Product Bulletin

Pressure Relief Valve Configuration with Galvanic Isolator

Galvanic Isolator Model

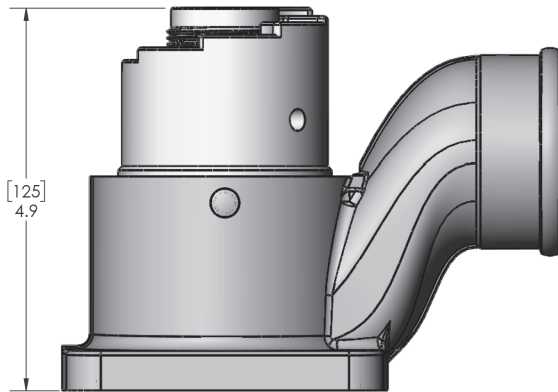
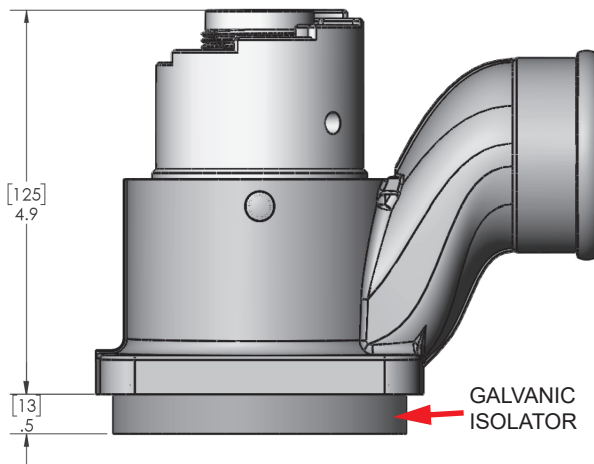
TFT now offers Pressure Relief Valve (PRV) configurations with an integrated galvanic isolator designed to mitigate the effects of corrosion for use with non-TFT products, or installed adjacent to materials other than aluminum.

The PRV model without the integrated galvanic is still ideal for use on TFT products and aluminum appliances. Contact TFT to confirm part number accuracy.

For use on non-Aluminum installations or installed on non-TFT products.

NOTE: Galvanic Isolator models require 1/2" additional bolt length to ensure proper thread engagement
